CITY OF LONG BEACH

DEPARTMENT OF PUBLIC WORKS

February 22, 2011

City of Long Beach Comments on the Draft Dominguez Channel and Greater Los Angeles and Long Beach Harbor Waters Toxic Pollutants Draft Total Maximum Daily Load and Related Documents and Concurrence with Comments Submitted by the Port of Long Beach

Location of Los Cerritos Channel Watershed (Freshwater)

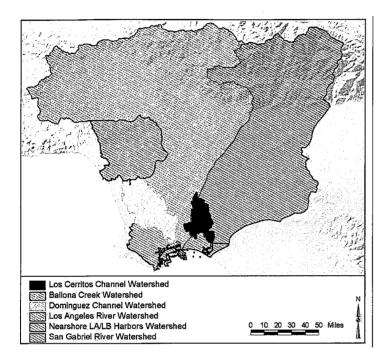
- 4. The Alamitos Bay watershed is incorrectly grouped into the Nearshore subwatersheds. (See Figure III-2, Appendix III). The Draft TMDL states that "These Nearshore areas refer to freshwater inputs that discharge directly into the saline receiving waters without passing through the Channel or Rivers." The freshwater portion of the nearly 18,000 acre Los Cerritos Channel watershed (shown in the figure below) comprises a large portion of this watershed. The Bouton Creek watershed consisting of 2,260 acres is located adjacent to the Los Cerritos Channel watershed and discharges into the estuarine portion of the Los Cerritos Channel.

Suspended sediments from stormwater water discharges into Alamitos Bay rarely pass entirely through the Bay and into San Pedro Bay. Stormwater plumes from these watersheds were monitored during a number of early season storm events that occurred from 2002 through 2006. The vertical and horizontal extent of the plumes were mapped with GPS-tracking and a series of water quality profiles. The plume was sampled at four different dilutions (based upon salinity) and sampled to measure dissolved and total metals concentration and toxicity. The plume was typically found to be contained within Alamitos Bay except during extremely large events. Even during large events, the plume becomes difficult to delineate in between the breakwater at the entrance to the Bay. Details of these plume studies are included in the City's Annual Stormwater Monitoring reports.

The appropriate area of the City of Long Beach to be included with the "Nearshore Group" would be the San Pedro Bay subwatershed that is identified on page 44 of Appendix II (Figure 23. Waterbodies and Bight 03 Stations Assigned to Model Subwatersheds).

PLATE 1: HISTORICAL SURFACE DDT CONCENTRATIONS IN PORT OF LOS ANGELES (PRE - 1990)

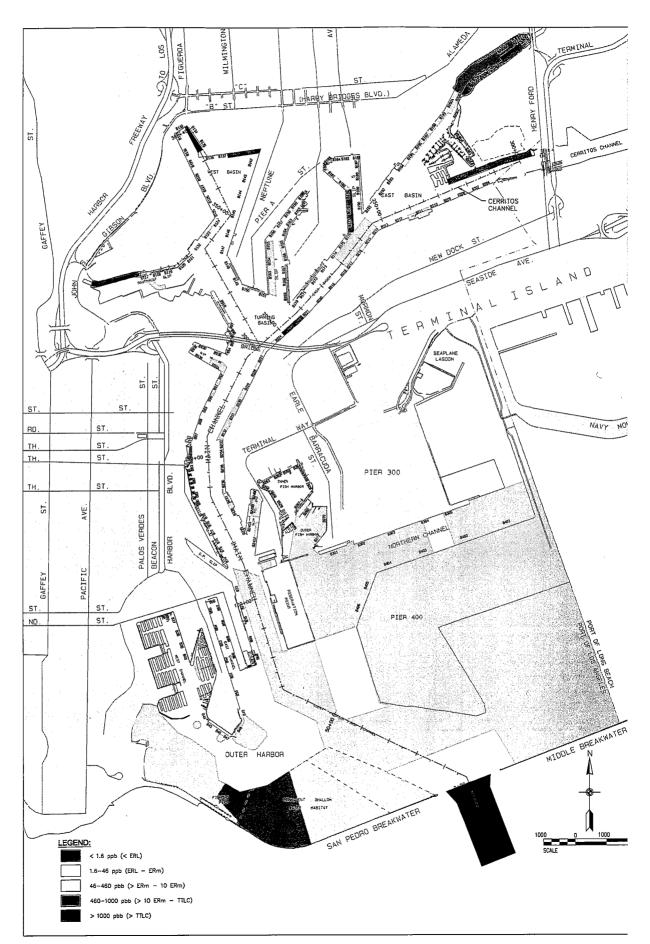
There are a number of problems with this approach. Maintenance and deepening dredging has taken place within the Port of Los Angeles (POLA) and as part of the Channel Deepening and POLA improvement projects. Total dredge volumes of approximately 81 million cubic yards were removed by deepening down to virgin sediments removing extensive contamination from the majority of the Port. These virgin sediments would have non-detect levels of DDT. Although it is recognized that recontamination of the virgin material can occur through suspension during the dredging process and advection from the Dominguez Channel and Consolidated Slip, it is clear that conditions have radically changed (see attached Plates showing pre 1990 and post 2007 conditions). Another problem with this approach was the use of the Bight 03 data to represent sediment concentrations associated with subwatersheds draining to Consolidated Slip. The values used in Table 12 of Appendix II (page 46) were among the lowest of all three organic contaminants. In reality, they are known to be among the highest concentrations found in the region. The geometric mean of total DDT concentrations measured in 5 sediment samples from Consolidated Slip sediments in 2002 (Karen and Byron, 2003) was 475 µg/kg-dry. The LSPC model used a mean value of 1.3 µg/kg-dry. While this may be a relatively small subwatershed, it suggests that similar problems may exist elsewhere especially in areas subject to periodic intense flows that modify and transport bedded sediments.
